**RE: Sawmill Village Phase 2
Grading Plan
Stamp Date: 7/24/17
Hydrology File: H13D025A C**

Based upon the information provided in your submittal received 7/24/17, the Grading Plan is **not** approved for Building Permit. The following comments need to be addressed for approval of the above referenced project:

CITY OF ALBUQUERQUE	
PAVING	
PRIVATE ENTRANCE DETAILS - ILLUSTRATING TWO SEPARATE R/W CONDITIONS.	
DWG. 2426	
REVISIONS	
1/91	
11/14/91	
4/4/94	
AUG. 1986

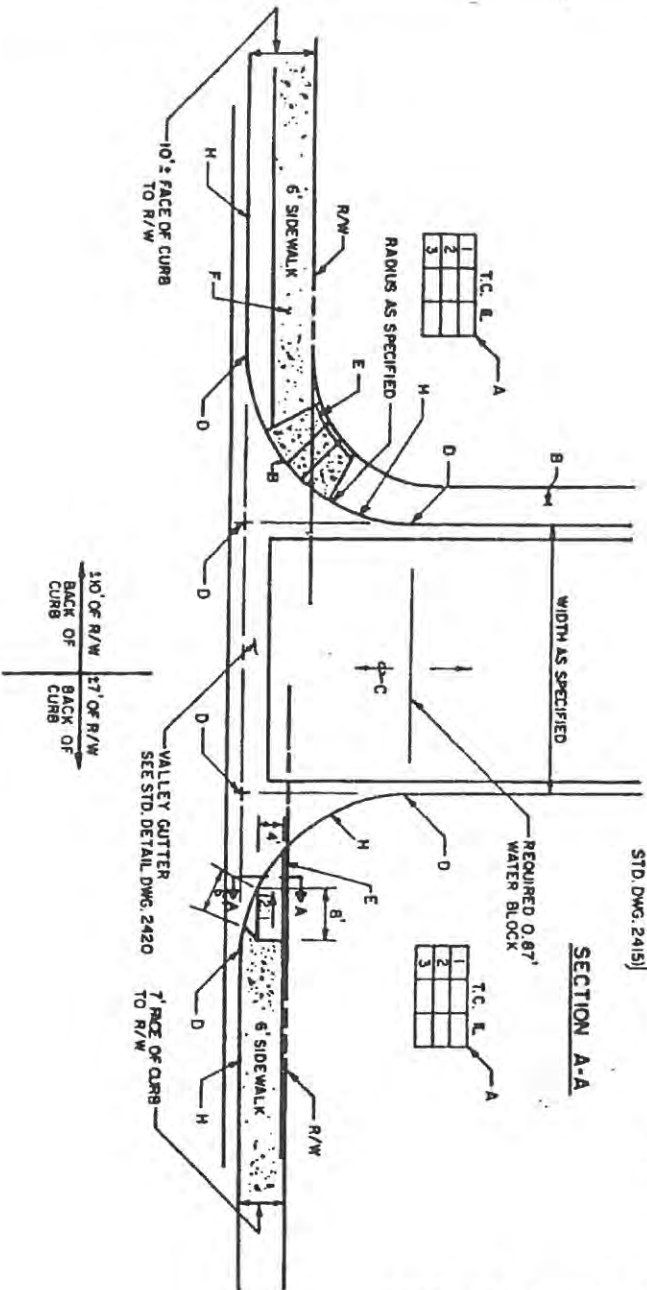
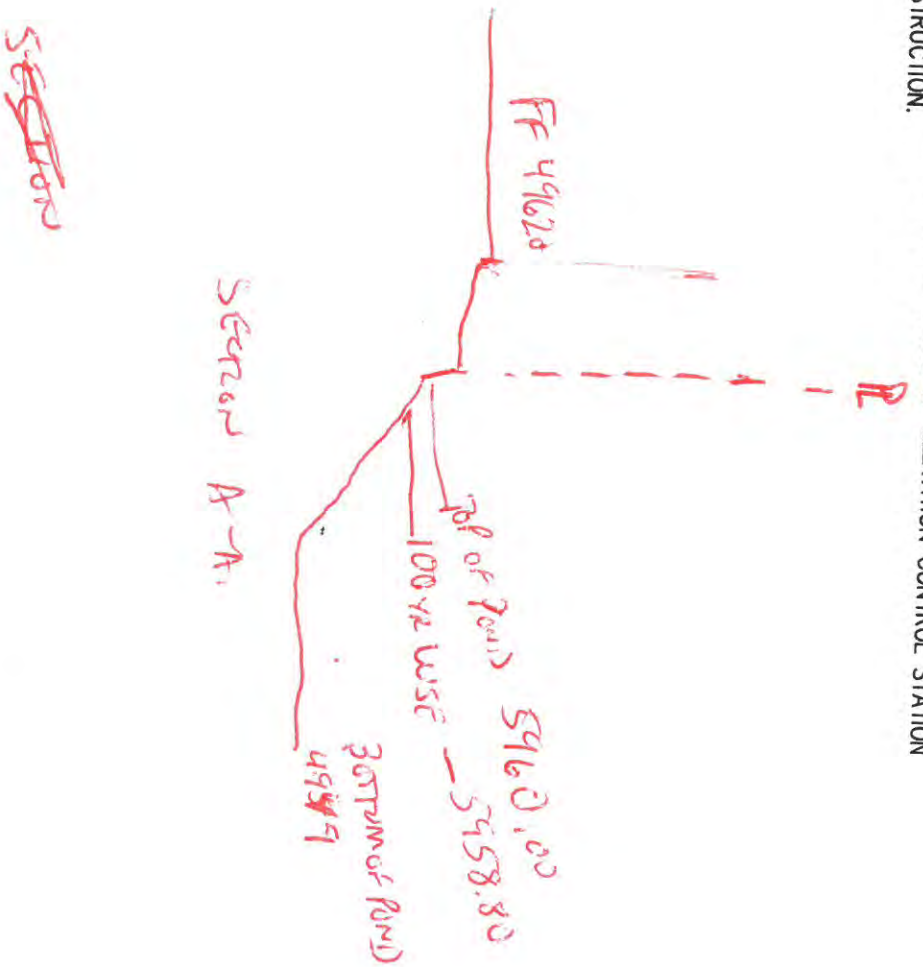
1. Please provide the required 0.87' water block per COA Paving Detail No. 2426.
2. Please provide the three point chart for each driveway radius per COA Paving Detail No. 2426.
3. Please provide a section through the proposed building and existing adjacent pond. Please label the elevations of the top of pond, the bottom of pond and the 100 year WSE.

I have attached the COA Paving Detail No. 2426 and the proposed section for your use.
